UNITED STATES PATENT AND TRADEMARK OFFICE

APPLICATION NO.	FILING DATE	FIRST NAMED INVENTOR	ATTORNEY DOCKET NO.	CONFIRMATION NO.
10/534,999	12/20/2005	Josef Wimmer	037068.53616US	1997
23911	7590	10/03/2007	EXAMINER	
CROWELL & MORING LLP INTELLECTUAL PROPERTY GROUP P.O. BOX 14300 WASHINGTON, DC 20044-4300			NGUYEN, XUAN LAN T	
		ART UNIT	PAPER NUMBER	
		3683		
		MAIL DATE	DELIVERY MODE	
		10/03/2007	PAPER

Office Action Summary	Application No.	Applicant(s)	
	10/534,999	WIMMER ET AL.	
	Examiner	Art Unit	
	Lan Nguyen	3683

Crowell & Moring, LLP (202) 624-2500
Title: Disc Brake Having an Adjustment
Device in Particular for a Commercial Vehicle
First Inventor: Josef WIMMER
Docket: 037068.56316US

Fig. 1

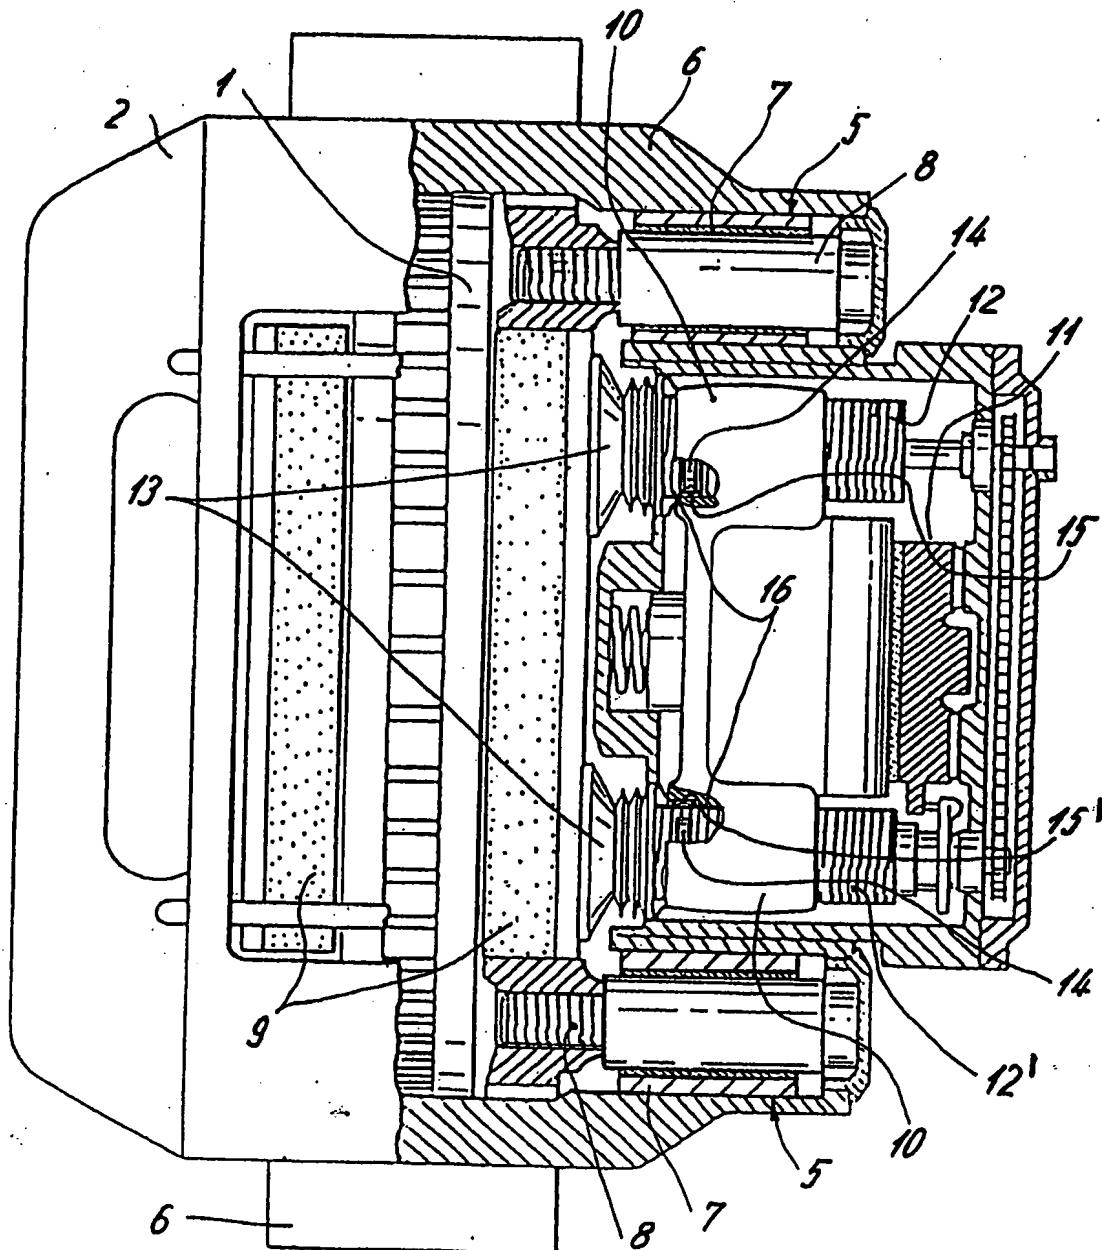
approved
XLU
9/25/07

FIG. 4

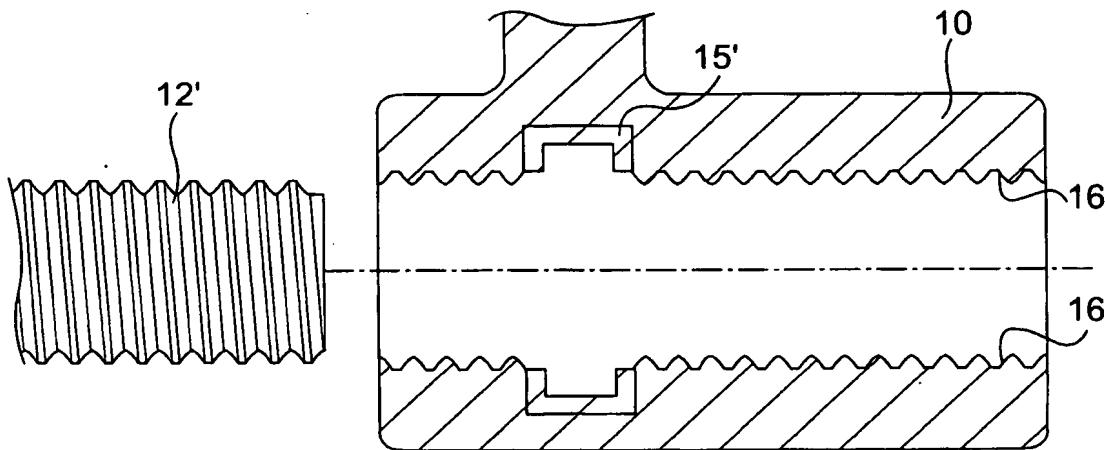
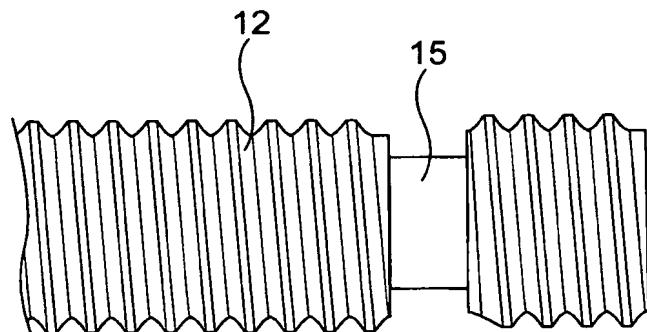
Approved
XLN
9/25/07
